# Space House, 43-59 Kingsway 2021/0351/P & 2021/0318/L

<b>Delegated Report</b>		<b>Analysis sheet</b>		<b>Expiry Date:</b>	<b>23/03/2021</b>
<b>(Members Briefing)</b>		N/A / attached		<b>Consultation Expiry Date:</b>	<b>07/03/2021</b>
<b>Officer</b>			<b>Application Numbers</b>		
Laura Hazelton			(i) 2021/0351/P (ii) 2021/0318/L		
<b>Application Address</b>			<b>Drawing Numbers</b>		
Space House 1 Kemble Street and 43-59 Kingsway London WC2B 4TE			Please refer to decision notice		
<b>PO 3/4</b>	<b>Area Team Signature</b>	<b>C&amp;UD</b>	<b>Authorised Officer Signature</b>		
<b>Proposals</b>					
<p>(i) Removal and like for like replacement of windows to the north and south of the Kingsway building, removal of link bridge roof, reconfiguration of the UKPN facade to the Kingsway block and removal of brickwork and replacement with louvres to the Tower UKPN substation.</p> <p>(ii) Removal and like for like replacement of windows to the north and south of the Kingsway block, removal of link bridge roof, reconfiguration of the UK Power Networks Distribution Network Operator (UKPN) facade to the Kingsway building and removal of brickwork and replacement with louvres to the Tower UKPN su

Existing Kingsway UKPN elevation

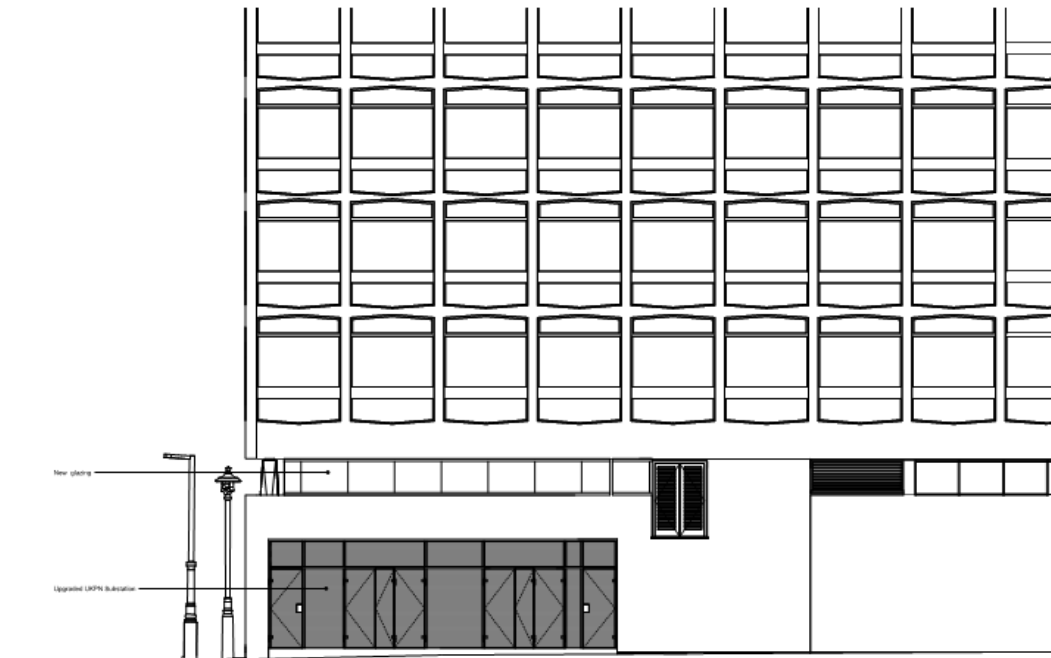
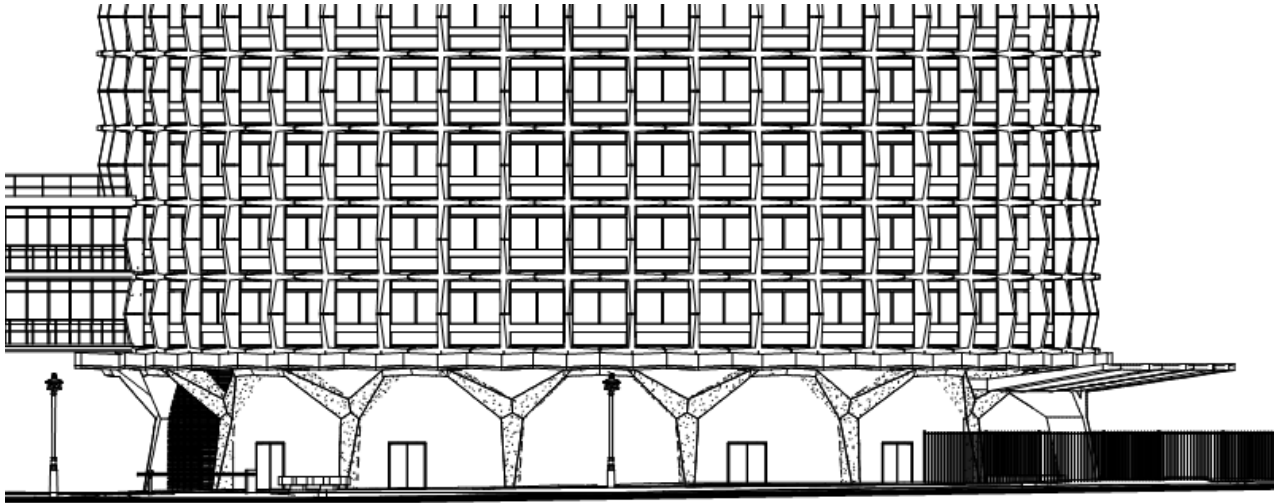
- 4.6 UKPN have confirmed that the existing Kingsway substation will need upgrading into a twin substation ahead of the main construction works at the site to provide sufficient power for the building. This will require an area of the Kingsway west façade to be demolished to facilitate the substation upgrade.
- 4.7 UKPN's ventilation requirements for the upgraded substation are larger than the existing arrangement, and require areas of ground floor and mezzanine slabs to be demolished, along with the removal of brickwork and existing louvres to the west facade. The proposed openings would appear more coherently arranged than the existing arrangement, and the impact on significance would be neutral. The final construction details and samples for the proposed UKPN substation upgrades are secured via Condition 3(l) of the Listed Building consent ref: 2019/2790/L.

Proposed tower UKPN elevation

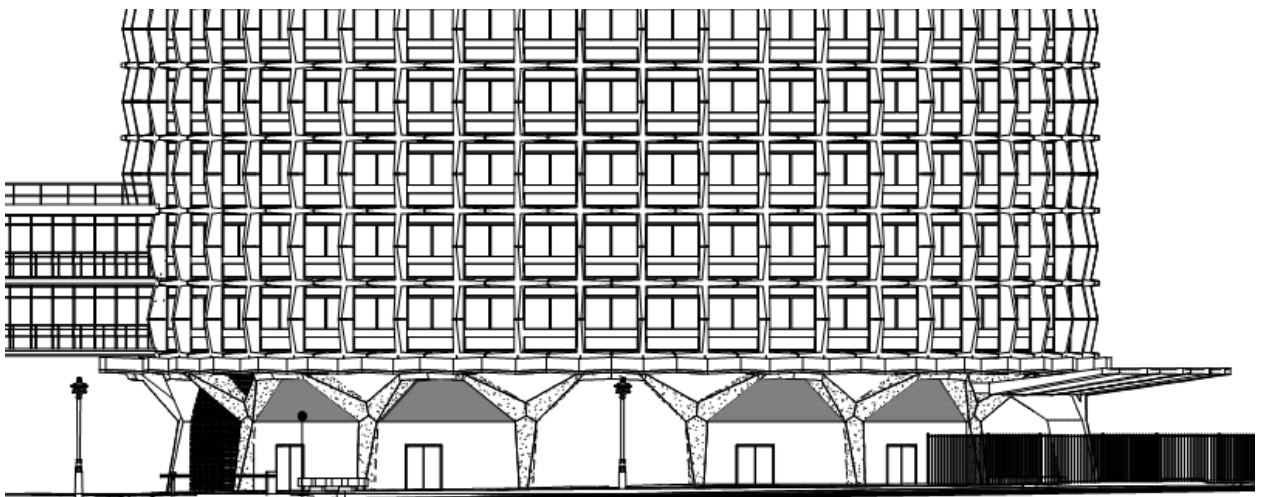
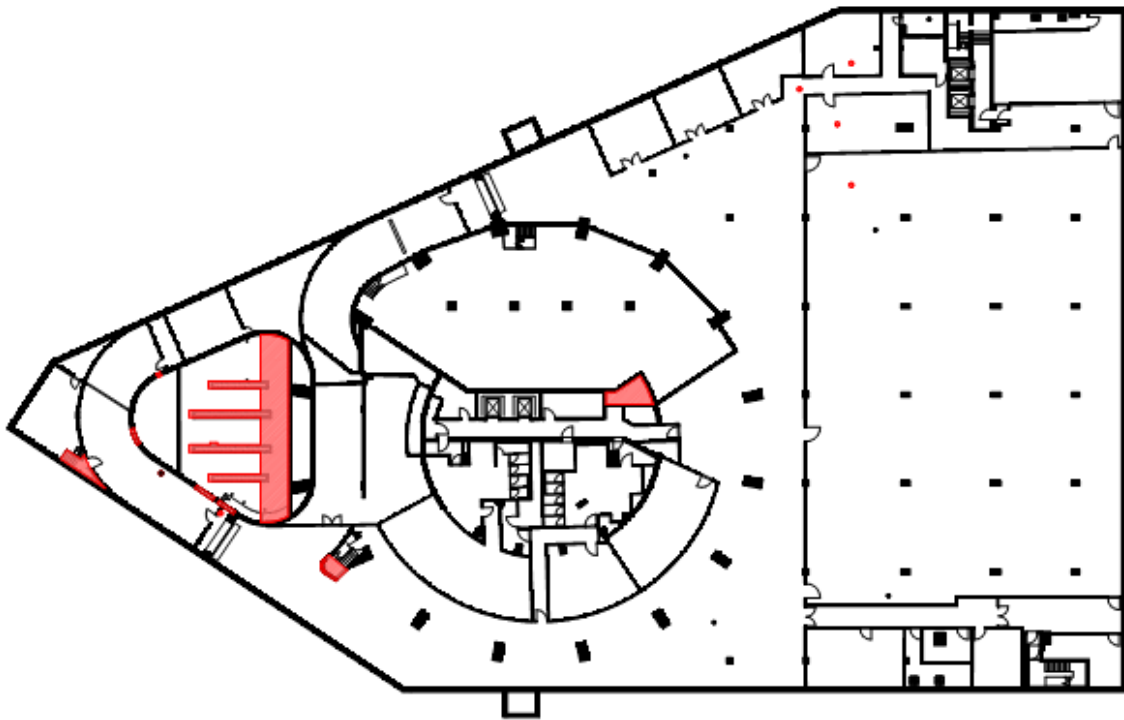
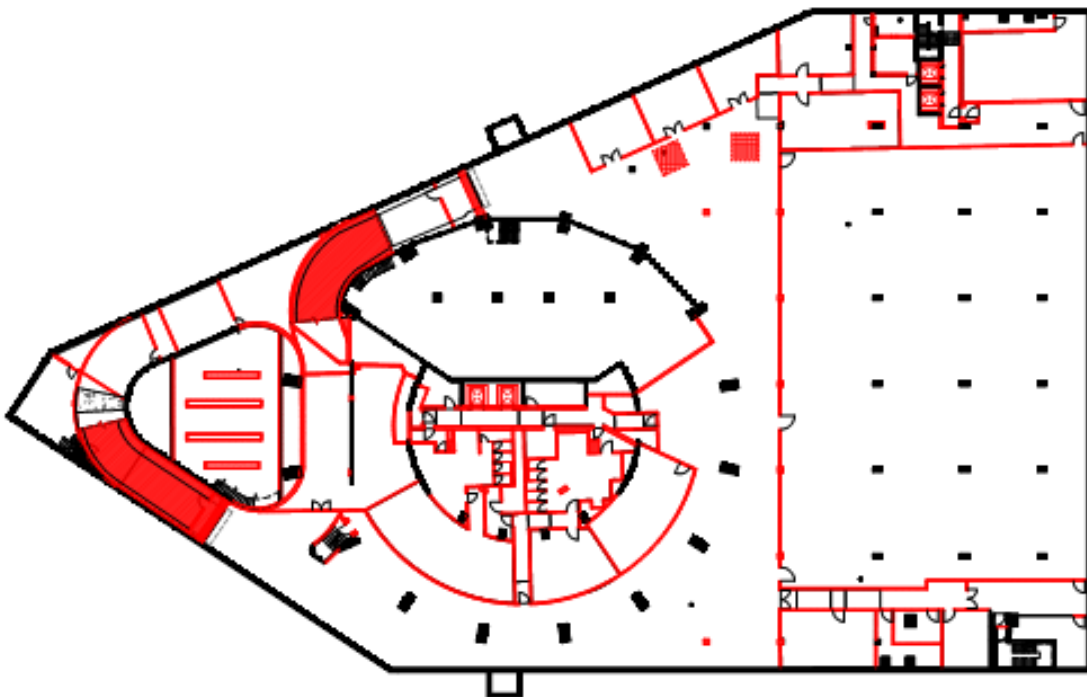
- 4.9 It is proposed to remove sections of high level brickwork to provide new louvres above the transformer bays that connect to the proposed redirected UKPN ductwork. The new louvres would be painted to match the colour of the existing louvres. As noted above, details and samples of the UKPN facade are controlled by condition 3(l) of the Listed Building Consent which remains to be discharged.

Proposed mezzanine demolition plan

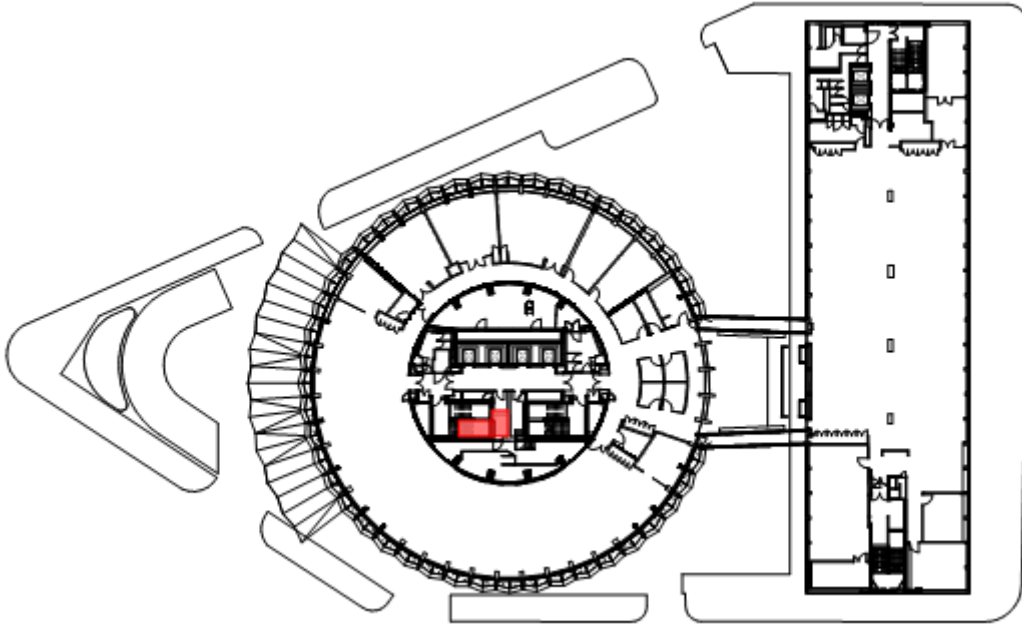
- 4.11 The additional demolition works proposed are the result of detailed design development which seeks to improve the design, safety, function and operation of the completed development. Since determination of the previous application, the existence of a mezzanine floor above the UKPN substations has also been discovered in both buildings and the proposals now include the demolition of a small element of this floor level.
